DESCRIPTIVE REPORT

Type of Survey Hydrographic
Field No. RA-10-10-97
Registry No. F00432

State Alaska
General Locality Stephens Passage
Sublocality Slocum and Limestone Inlets
and Taku Harbor

Descriptive Report to Accompany Hydrographic Survey FE-00432

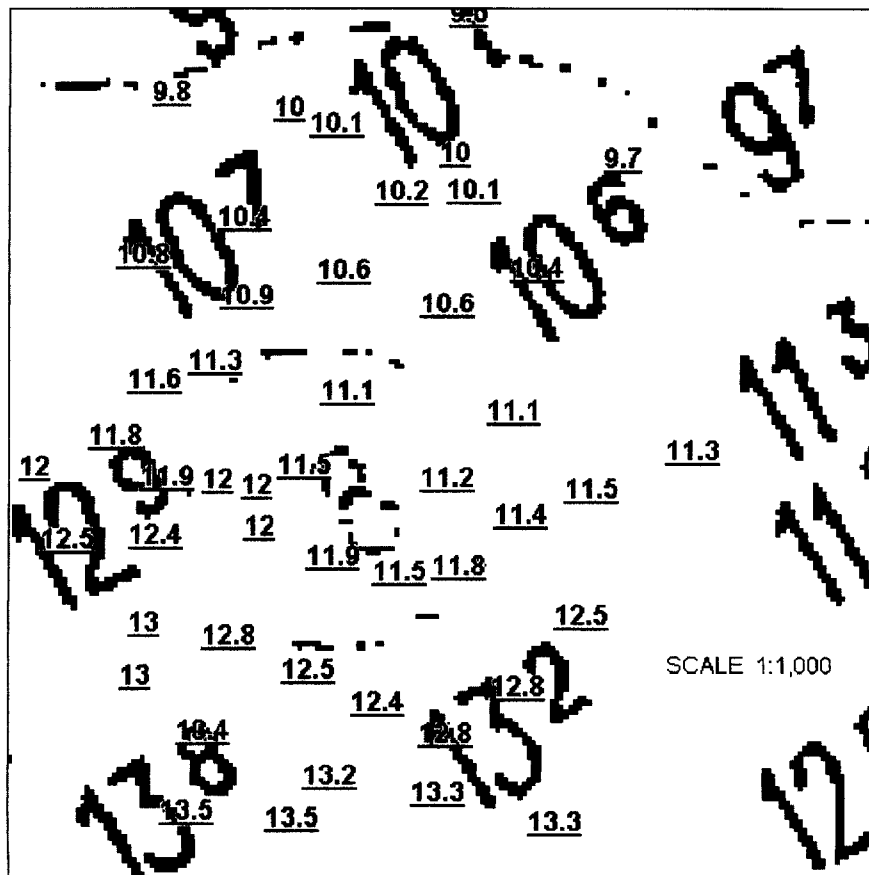
Hydrographer recommends charting the area as surveyed. It is likely that the unsupported and disproved soundings from 1997 were the result of a school of fish or other biomass that is no longer in the area. Contemporary soundings in bold red (underlined). Survey F00432 is the source for the prior soundings.

*Concur**Charted*

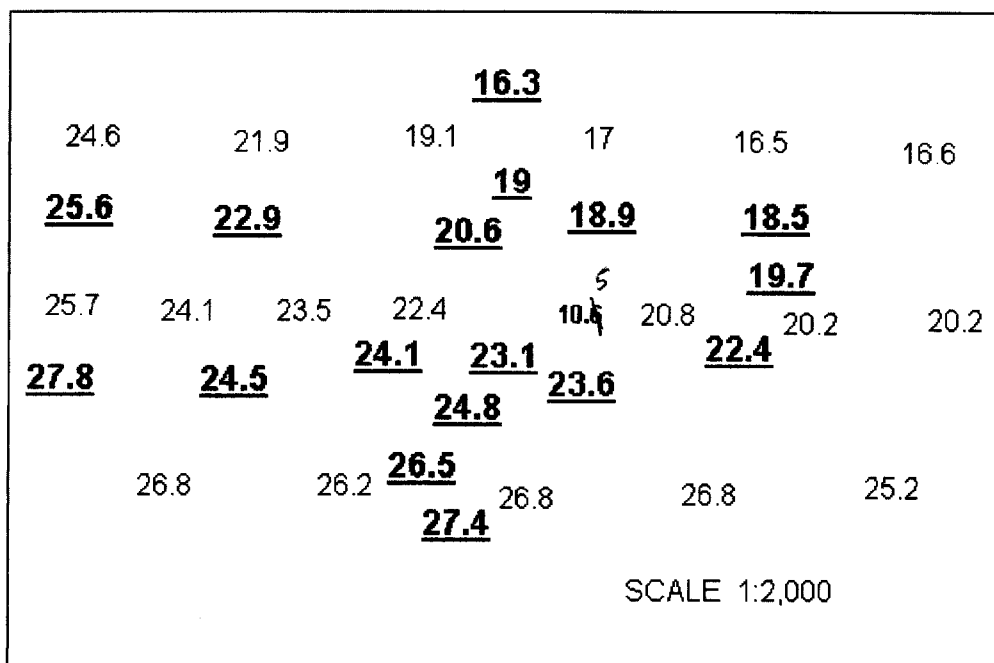
Concur
Hydrographer recommends charting the area as surveyed. It is likely that the unsupported and disproved 10.5 fathom sounding from 1997 was the result of a school of fish or other biomass that is no longer present in this area. Soundings in bold red (underlined) are from the contemporary investigation. Black soundings are from the 1997 survey. *Concur*

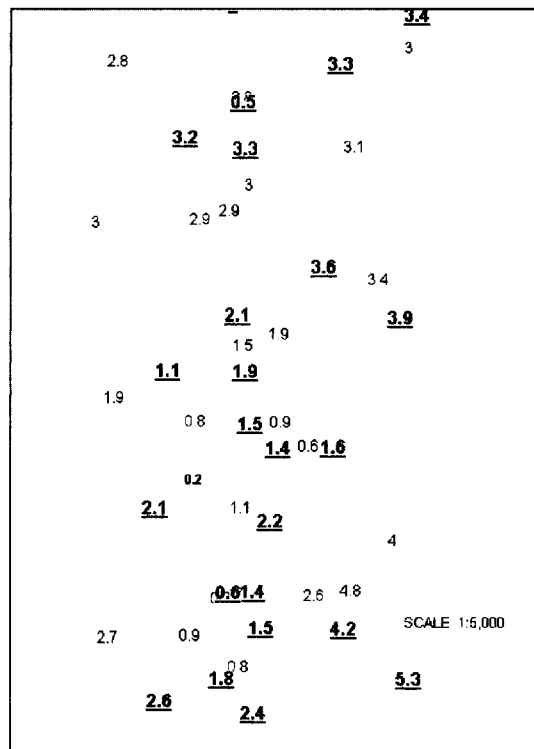
Hydrographer recommends that the least depths be chosen from a combination of the 1997 and 1998 data. *concur*
The surveys agree and together they define this shoal quite well. Soundings in bold red (underlined) are from the contemporary investigation. Black soundings are from the 1997 survey.

Charting Recommendation

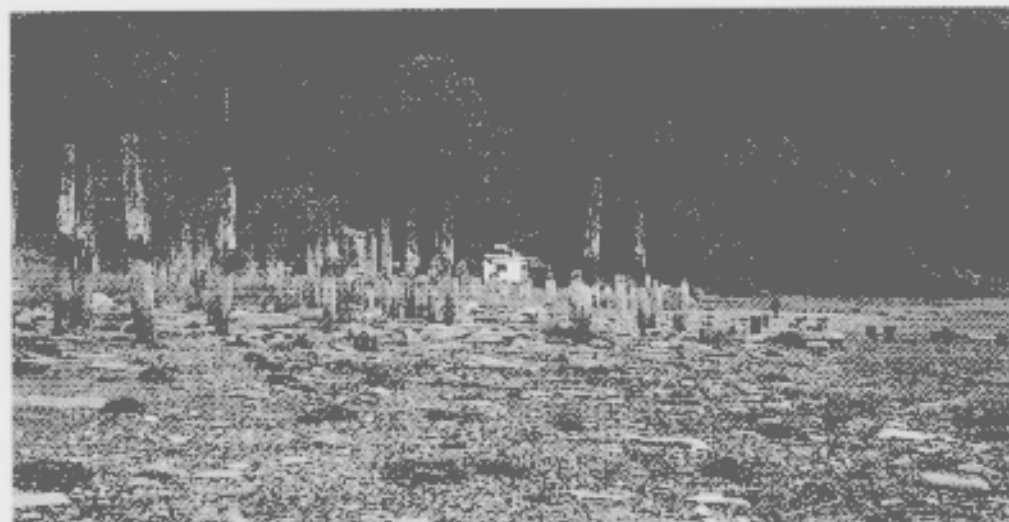
Hydrographer verifies this item carried forward from the prior survey but recommends charting as pilings. The digital image was taken facing Southeast. *Retained as charted.* *Do not contour*

Charting Recommendation

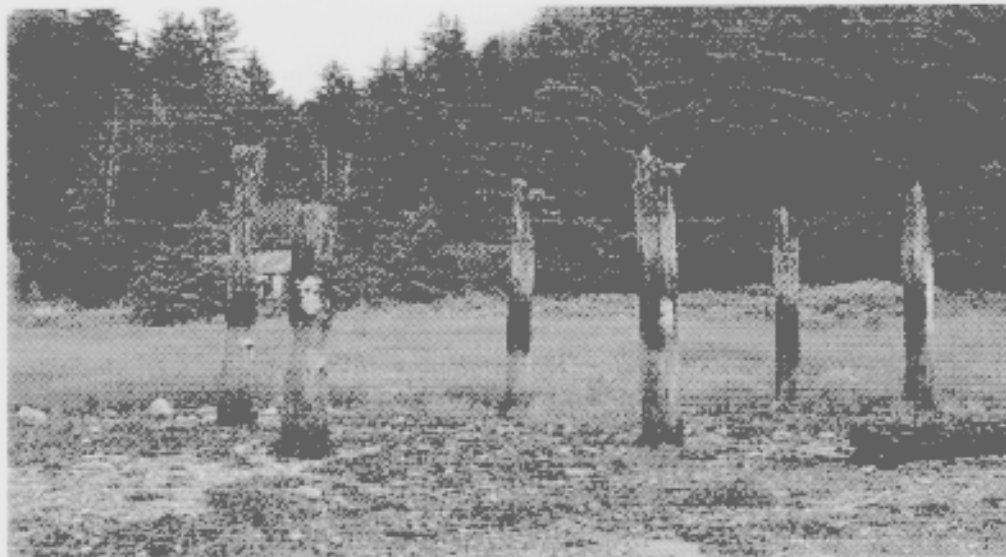
Hydrographer verifies this item ^{as found} ~~carried forward~~ ¹⁹⁹⁷ from ~~prior~~ survey but recommends charting as pilings. The digital image was taken facing Northeast. ^{Chart ruins} ^{Concur with}
^{classification}

Charting Recommendations ✓

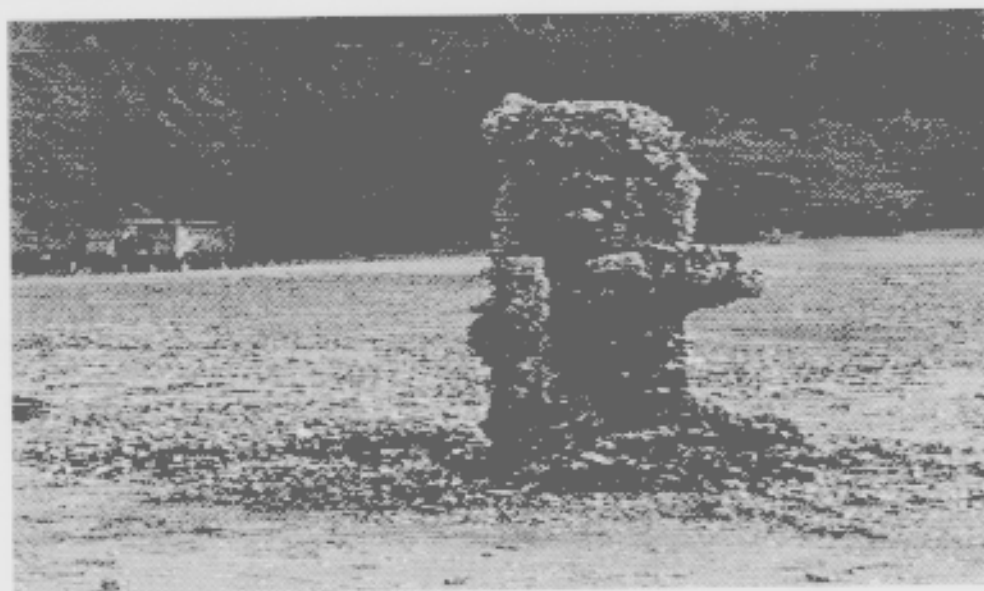
This pile is submerged at high tide and is a significant feature. Hydrographer recommends retaining the pile as charted. *Do not concur. This is not the charted pile. This is the pile portrayed on*

the smooth sheet & found in 1997. The charted pile originates from T-3870 (1920) and has been transferred in color to the smooth sheet.
